RM03-00001 CODE: D DD: A

DEC-O-LOG

Field Change Order Index

FIGURE 6

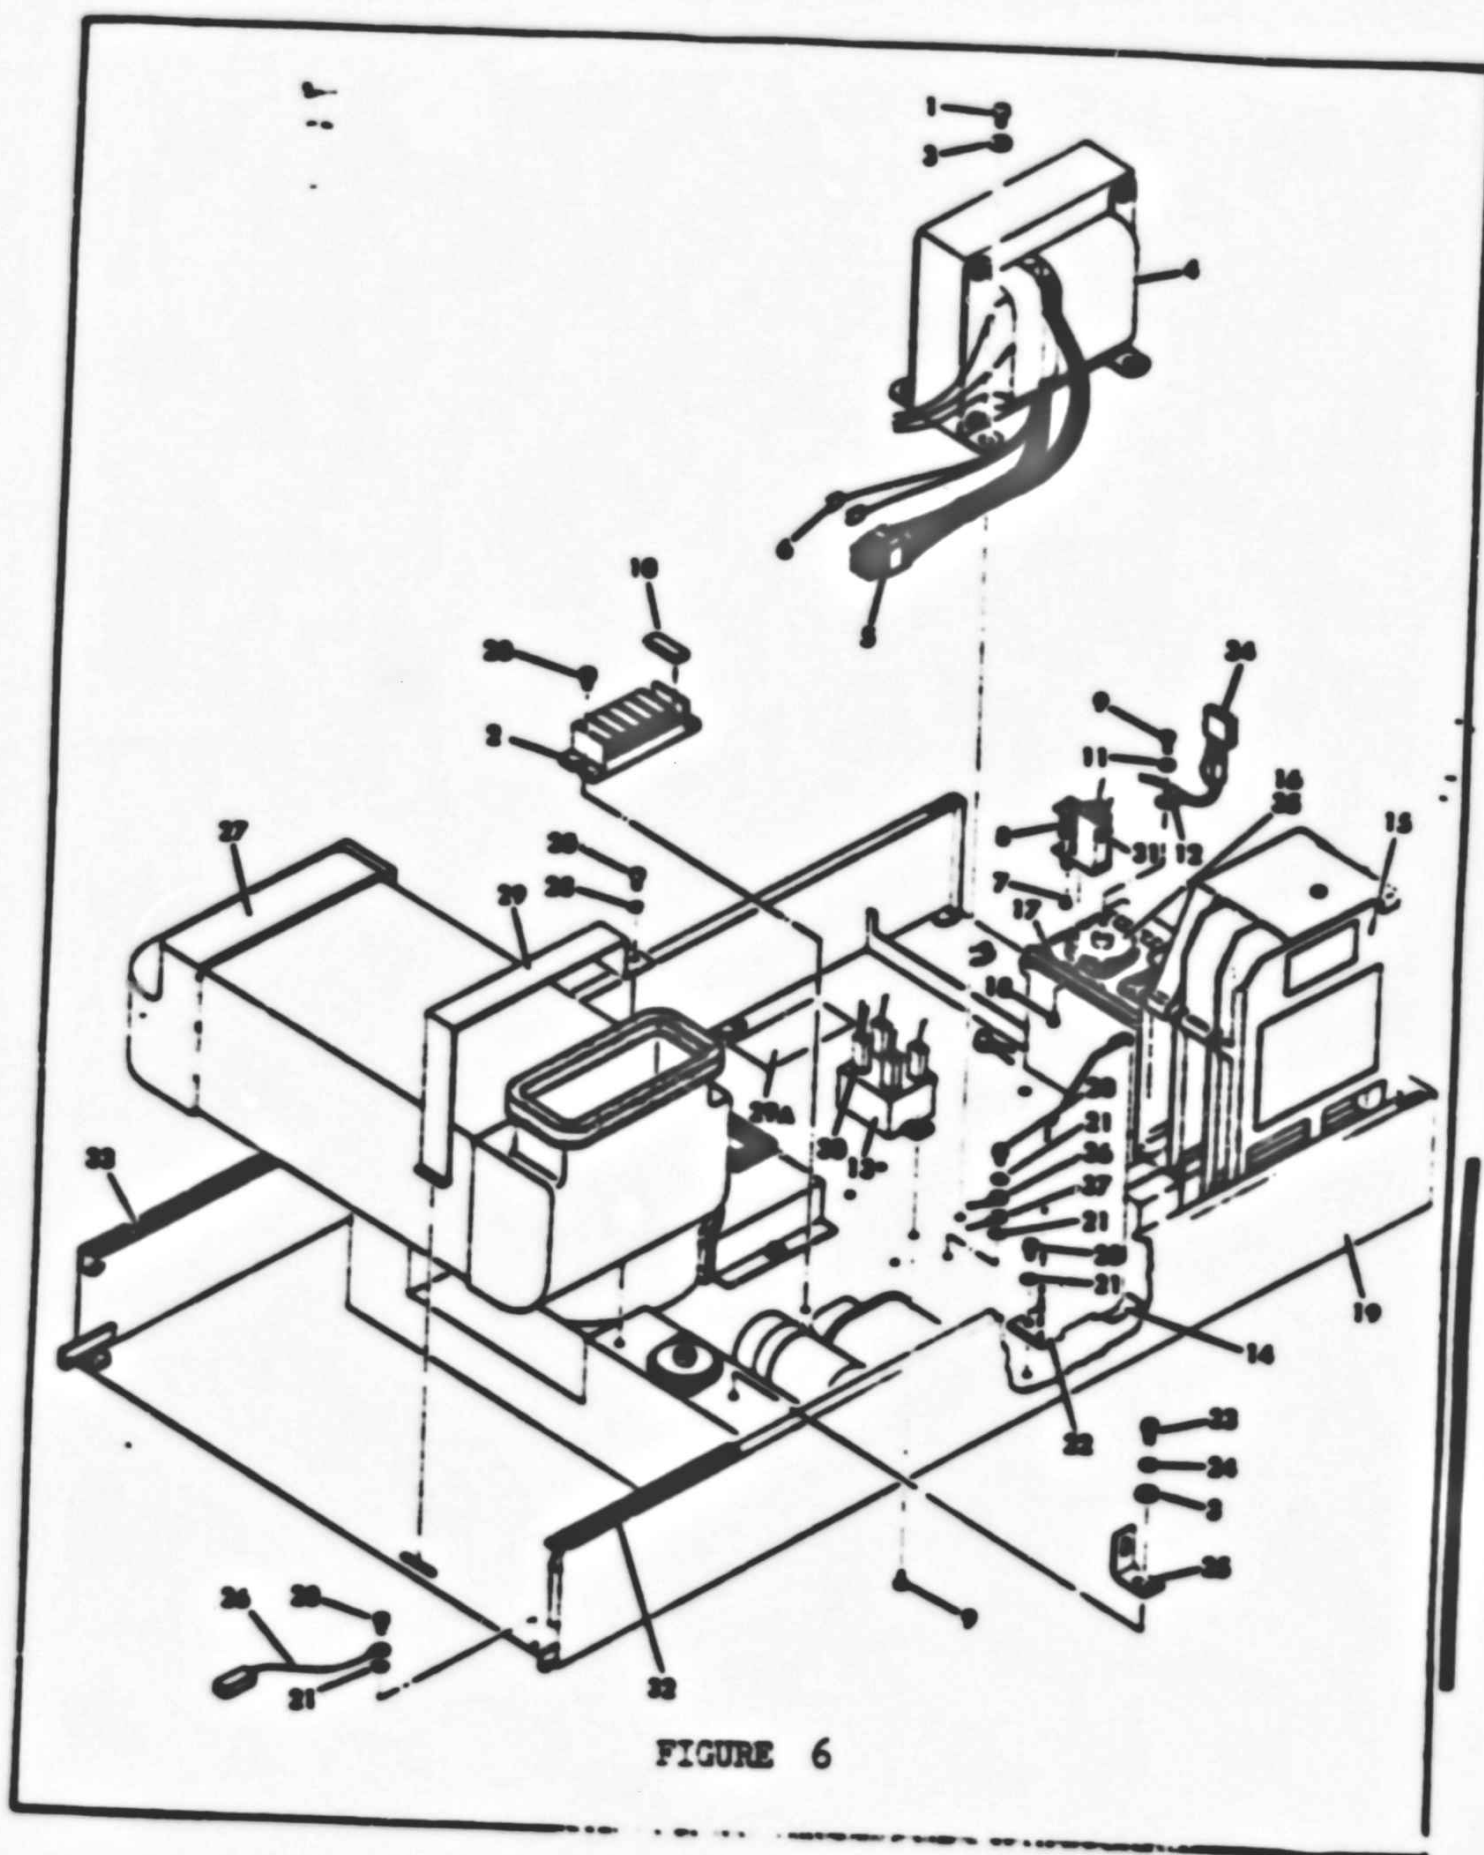
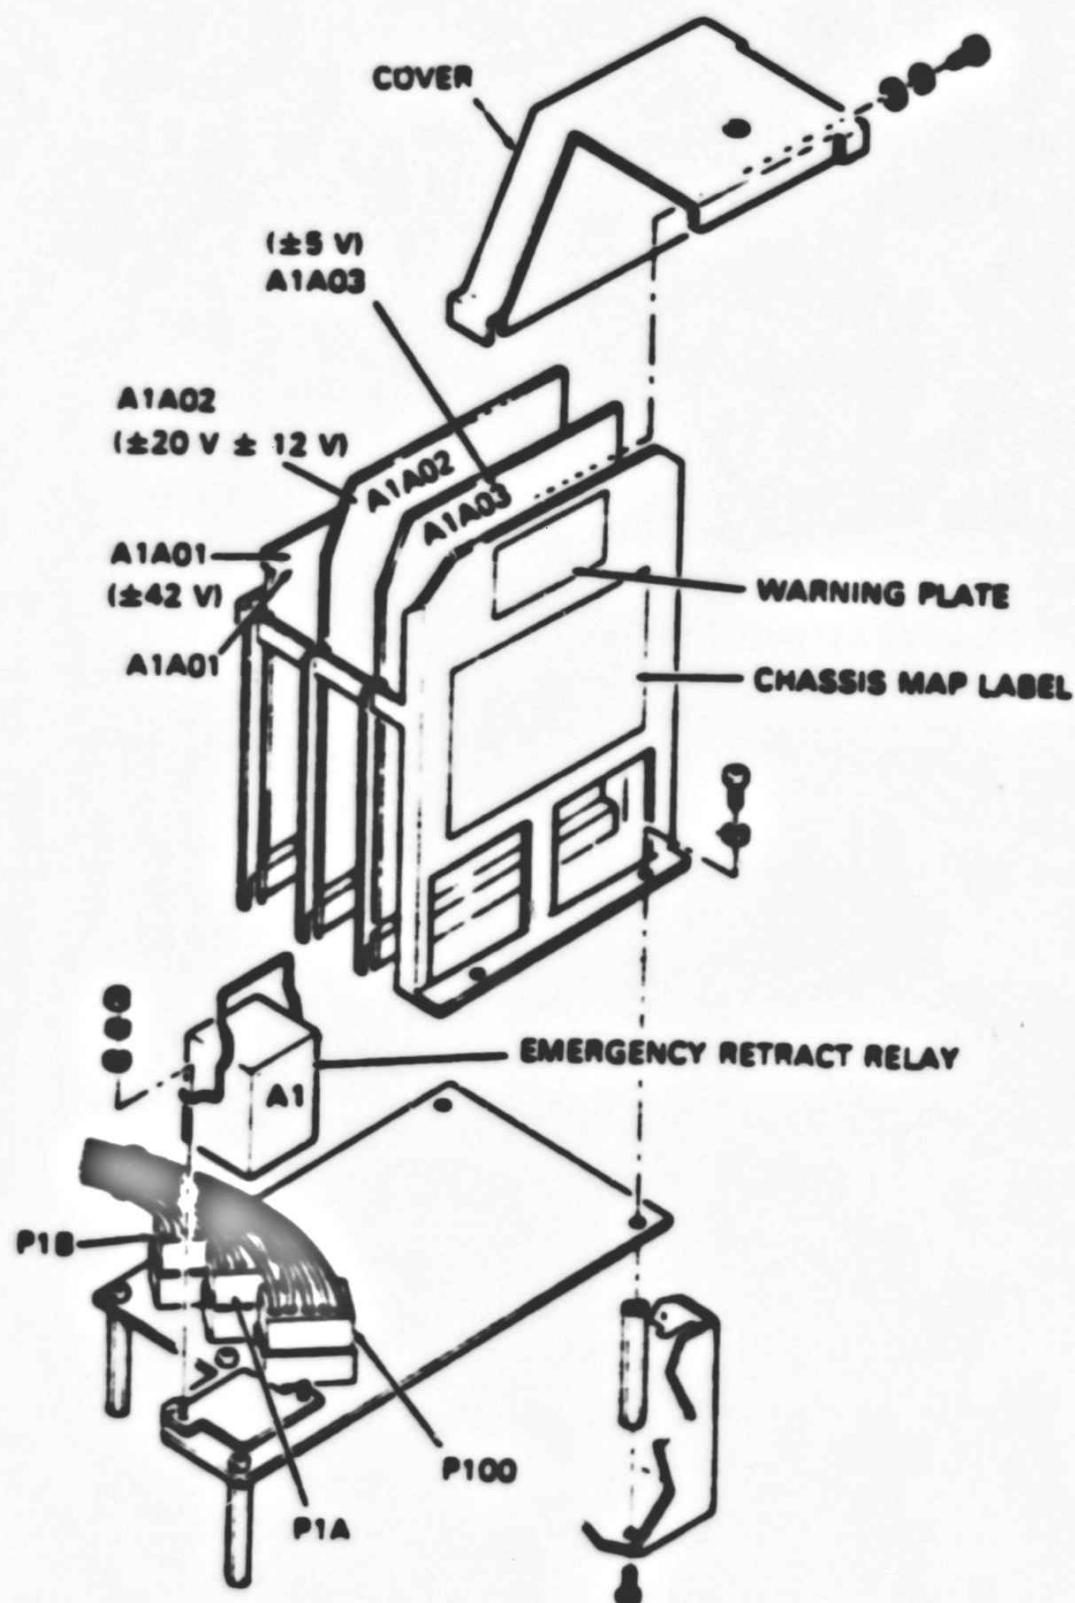
JUL 83 - PROBLEM: Transformer A1T1 can potentially short to deck plate due to insufficient adjustment travel in the mounting strap on the 50hz units.
CORRECTION: Incorporate Transformer with a new mounting strap on the failed units (50 hz only) per CDC NEC #J388.
IN-PLANT EFFECTIVITY: JUL 83

14. Remove the transformer (A1T1) and dispose of properly.
Note: cut the tie wraps if necessary.
15. Install the new FCO replacement transformer (CDC P/N 76846800) with new transformer mounting strap (CDC P/N 95656840) incorporated (supplied in the FCO parts kit using the hardware removed in steps 11 and 12).
NOTE: The new replacement transformer supplied with EQ-01334-01 has a new transformer elbow mounting bracket with slightly longer mounting holes to allow more tolerance in transformer adjustment. Refer to FIGURE 6.

FIGURE 3 VDE RM05 AC POWER CABLE

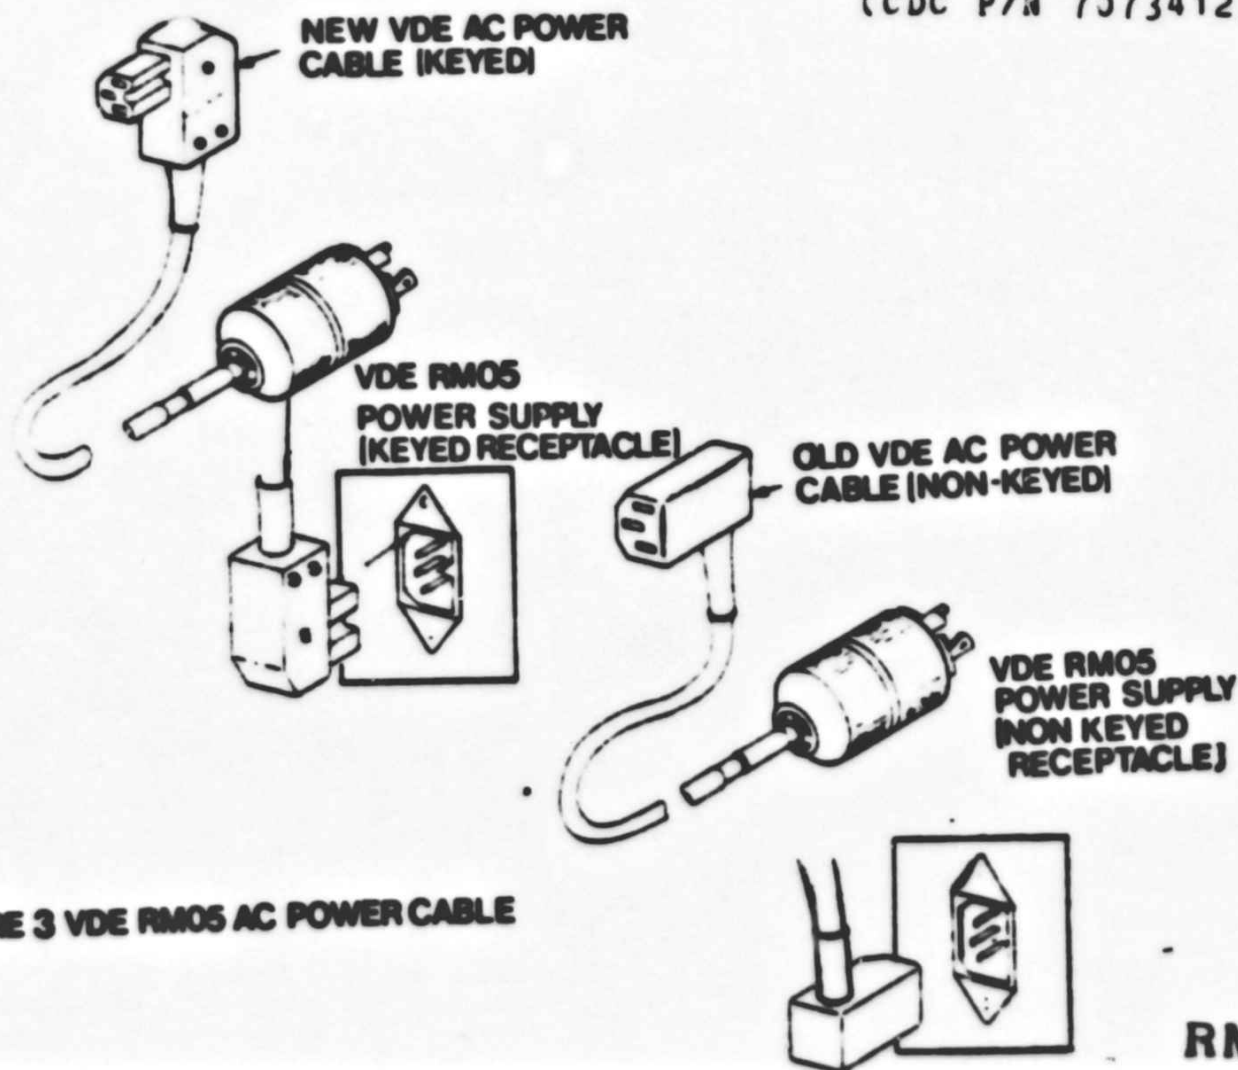
The new AC power cables may be used with any of the VDF power supplies, but the old AC power cables will not fit into the new VDF power supplies with the vendor part numbers 73133103 and the above. An example of the new "keyed" cable is shown in Figure 3.

Figure 1. OLD Non-keyed AC Power Cord (VDE)

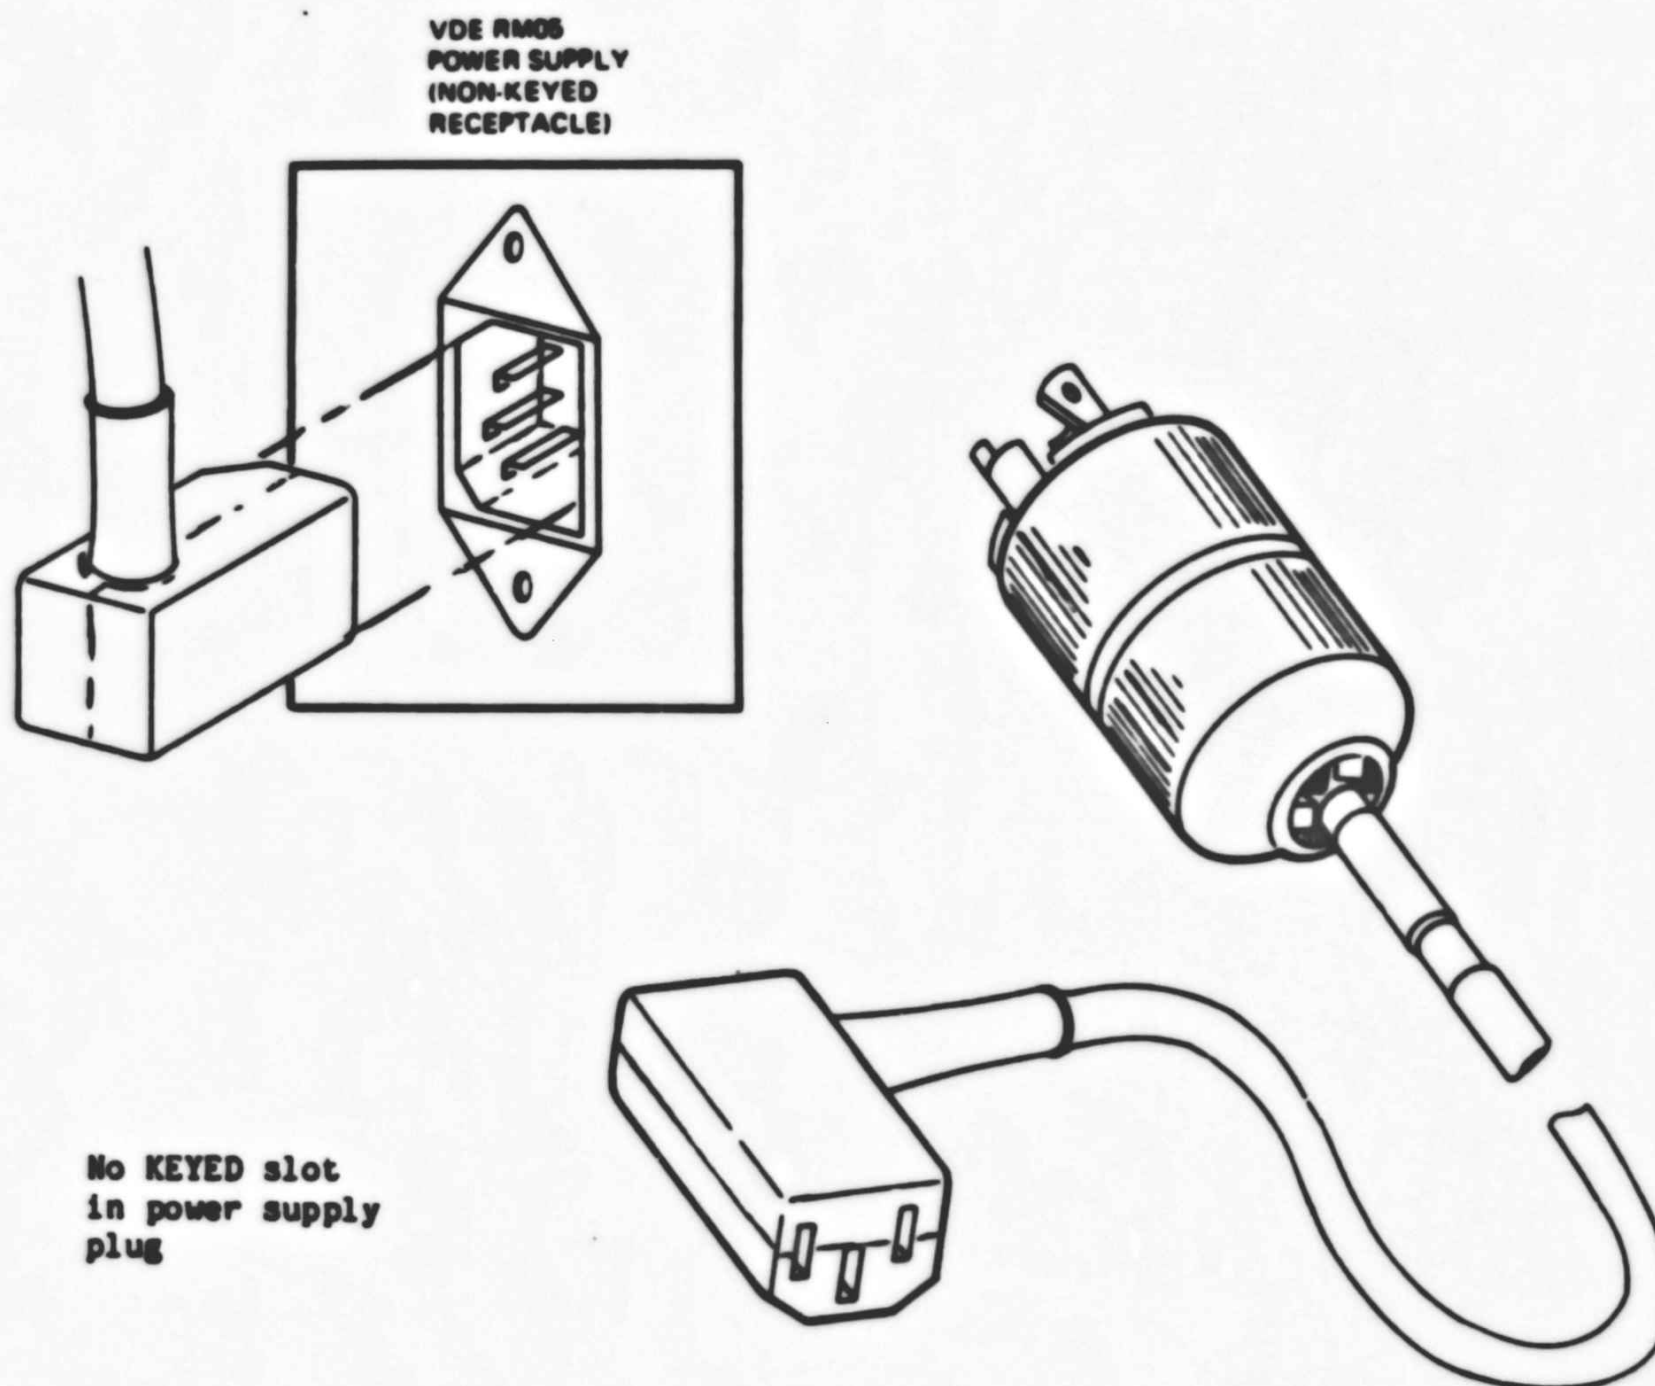
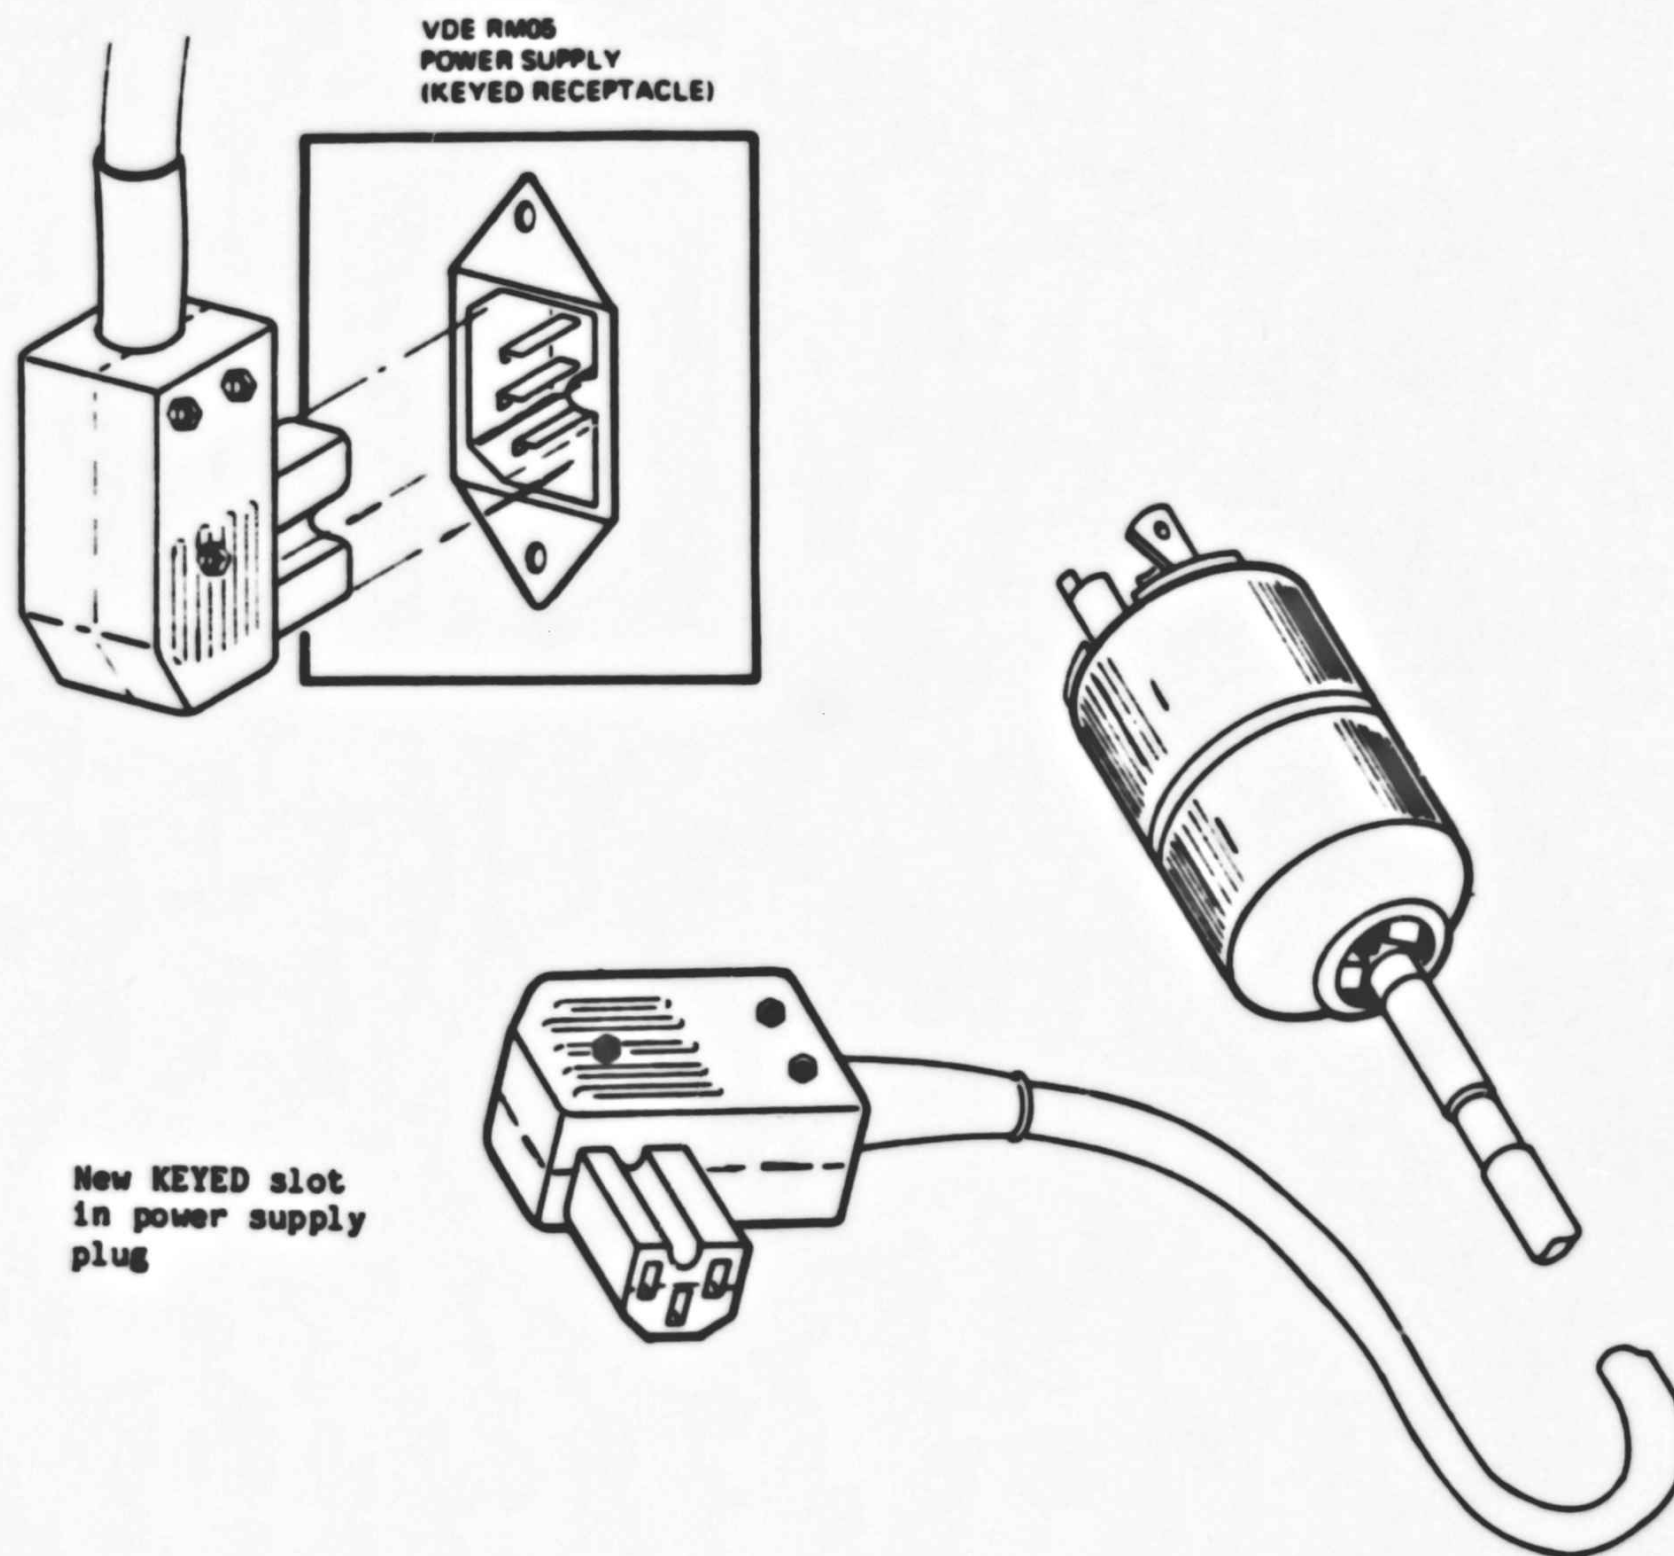
RM05 drives have started shipping with higher revision VDE power supplies using new "keyed" AC power cords to further meet VDE requirements. The new keyed power cords are compatible with ALL VDE power supplies. However, drives previously installed in the field may contain an earlier non-keyed AC power cords which WILL NOT FIT INTO the new VDE power supplies. Figure 1 and Figure 2 illustrate the physical differences between the keyed and non-keyed cables.
